Technical Service Information

THM 4L80-E CENTER GEAR BOX CHANGES FOR 1999 MODELS ("REVISED INFORMATION")

Figure 1

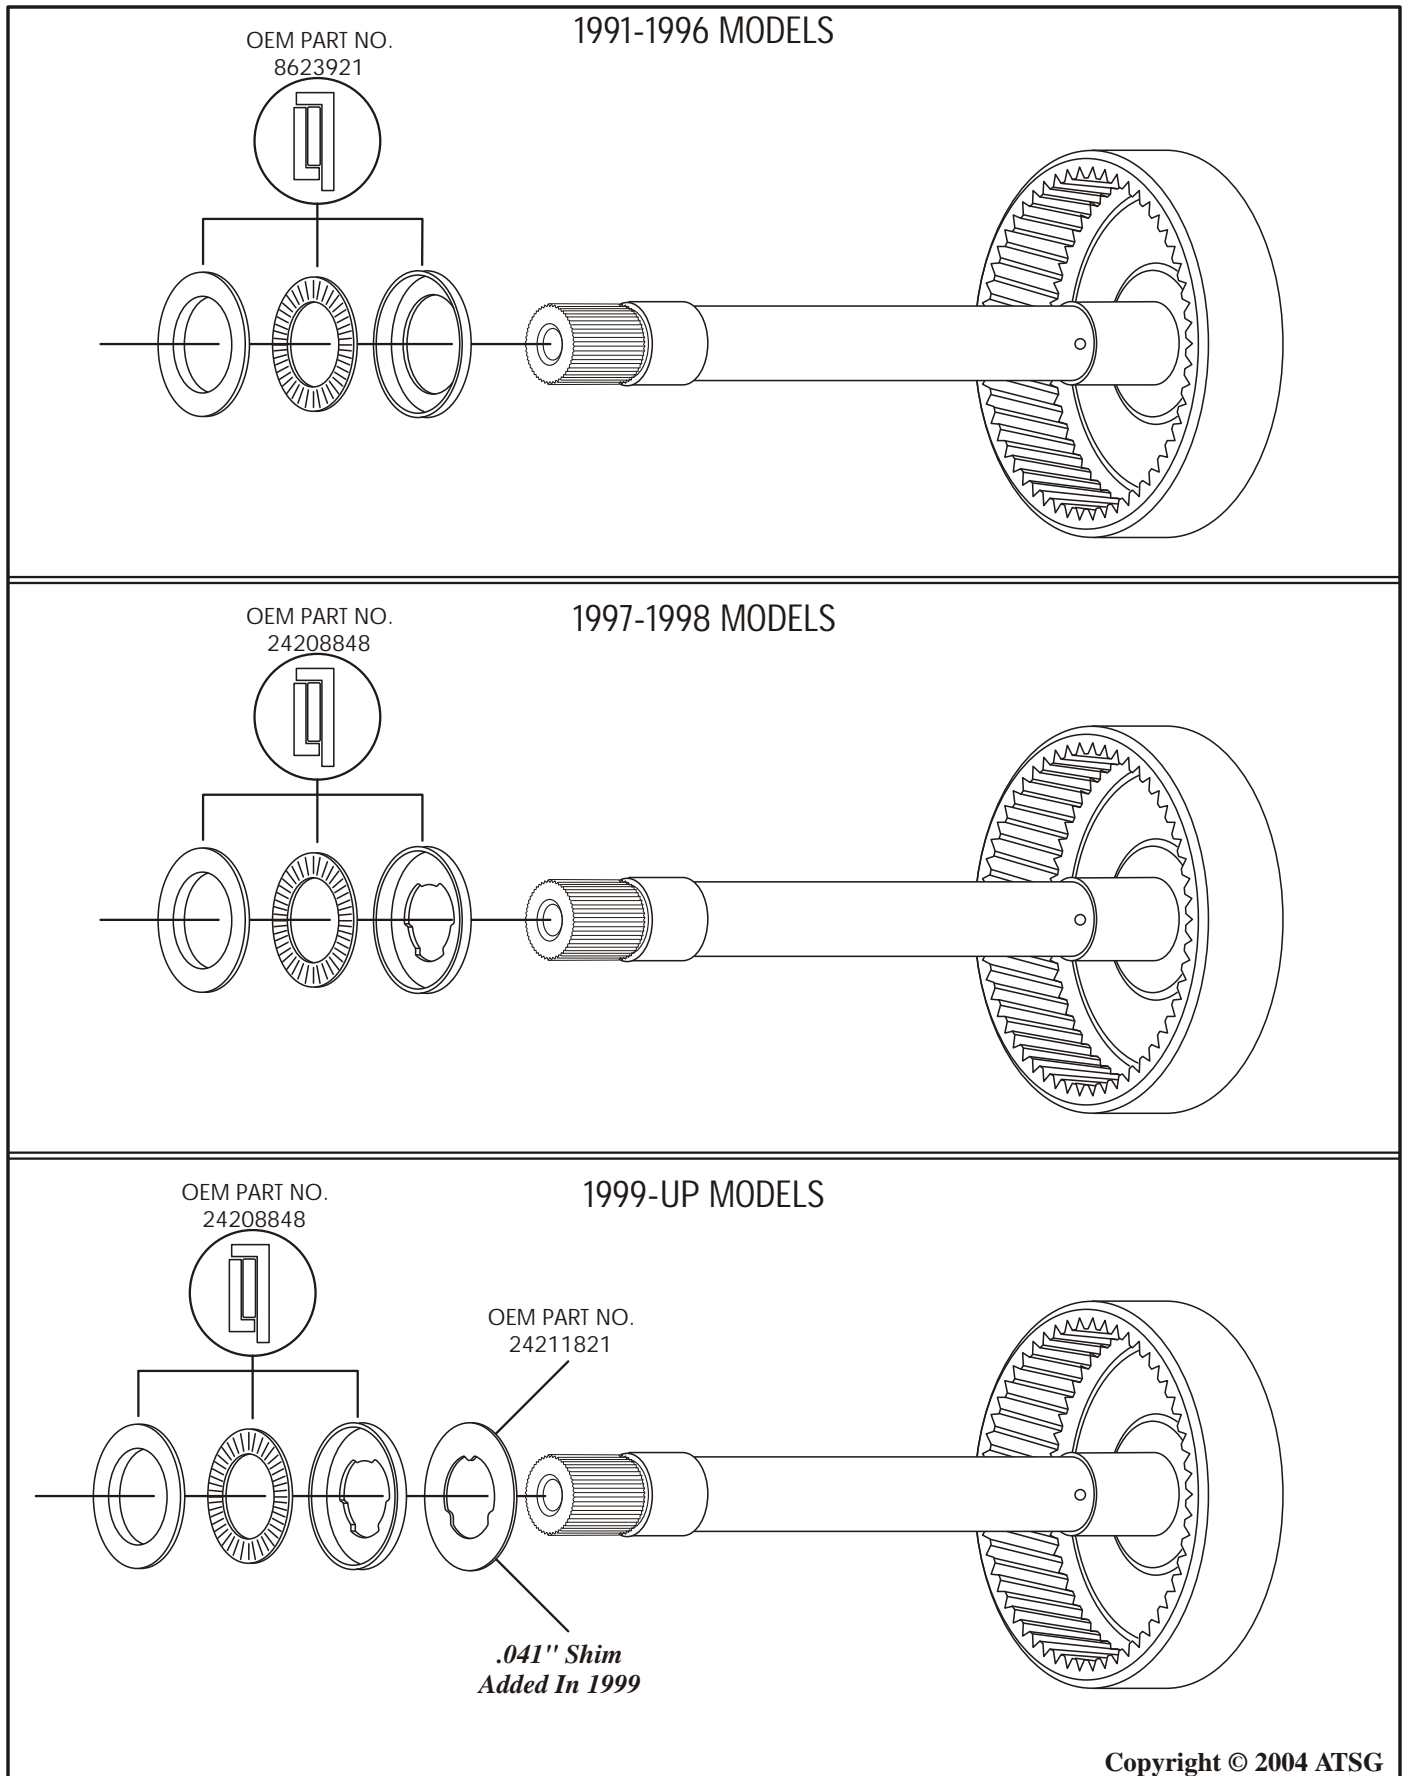
CHANGE: Beginning at the start of production for all 1999 model THM 4L80E transmissions, the planetary pinions on both carriers were produced 10% thicker than the previous models, as shown in Figure 1. This engineering change required the addition of a .041" shim in the gear train to re-center the sun gear in the new planetary pinions and affected several internal parts, that may create some confusion, and thus some mis-assembly concerns.

- (1) PLANETARY PINION GEARS - Were increased in length by approximately .075" in both front and rear carriers, as shown in Figure 1, for increased durability.
- (2) ADDED .041" SHIM - There was a .041" shim added between the thrust bearing and the rear internal ring gear, to re-center the sun gear in the revised planetary pinion gears, as shown in Figure 2.
- (3) CENTER SUPPORT - Required a .041" recess to be machined into the center support bearing surface, to accommodate the sun gear being re-centered in the revised planetary pinion gears, as shown in Figure 3.

Figure 3

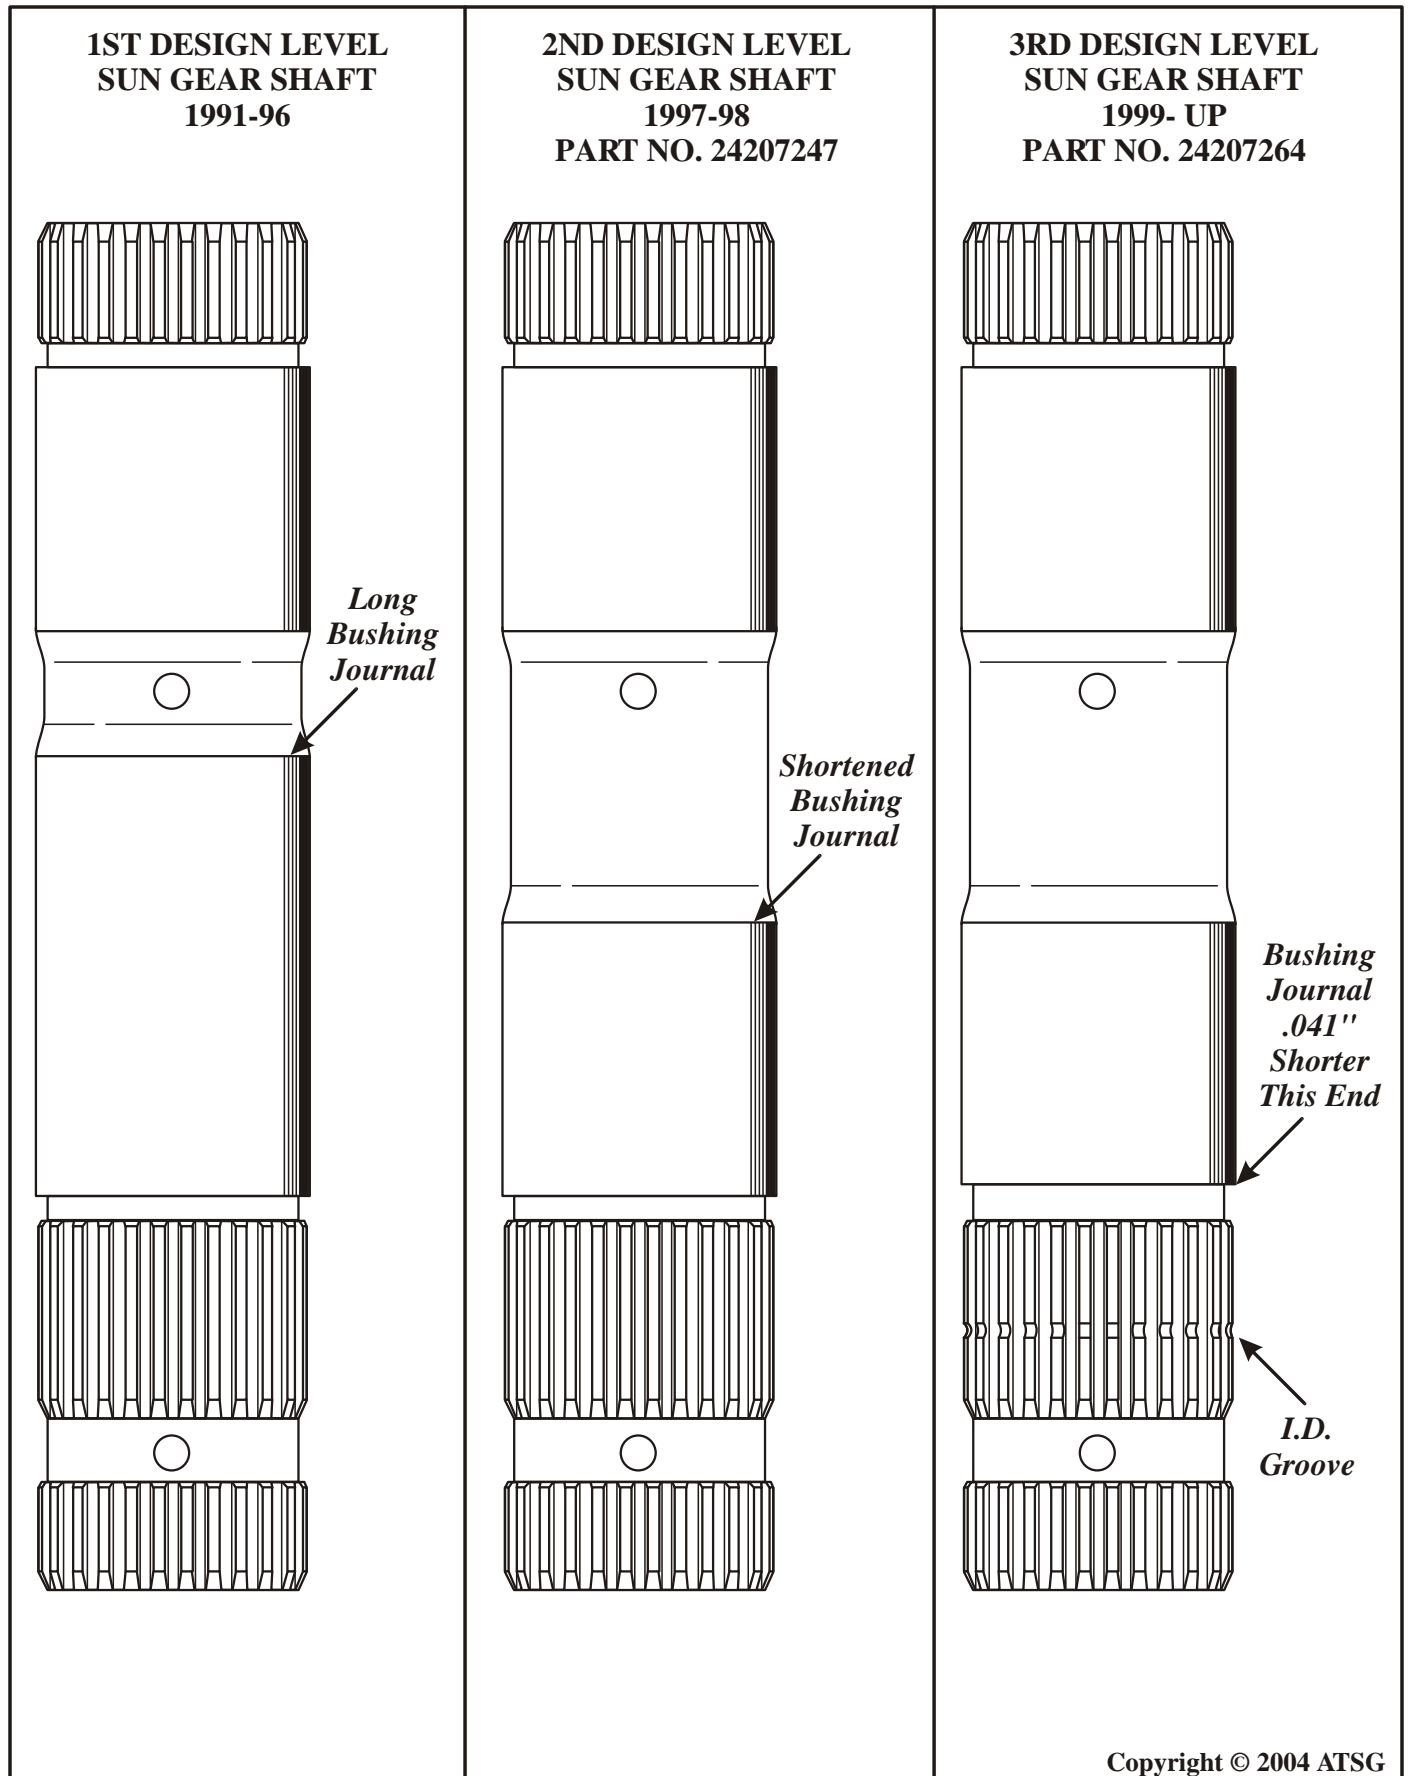
SPECIAL NOTE: Sometime in 2000 GM. eliminated the only visual identification from the updated center support and it now "Requires" measurement for identification, as shown Figure 3.

Figure 4

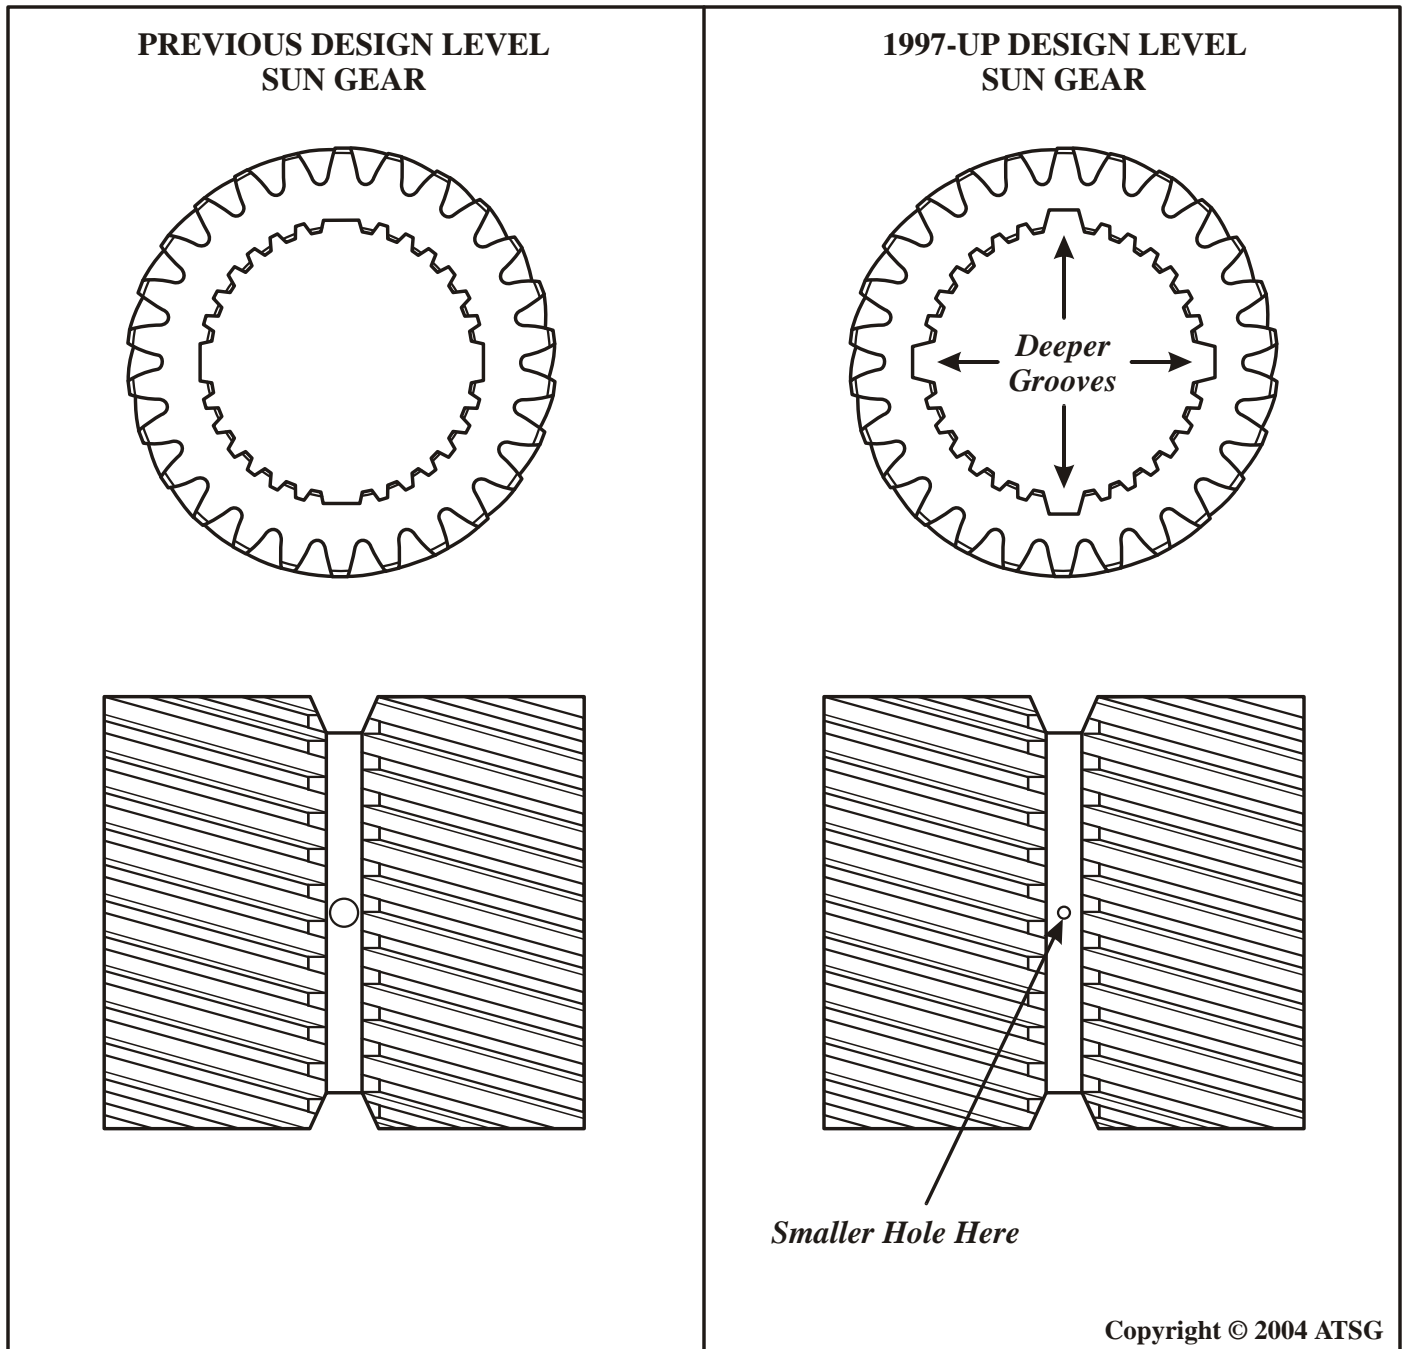
- (4) SUN GEAR SHAFT - Required that .041" be removed from the bottom of the rear bushing journal, to accommodate the re-centering of the sun gear in the revised planetary pinion gears, as shown in Figure 4. Notice that revised sun gear shaft can be identified with a groove cut into the shaft splines, as shown in Figure 4.
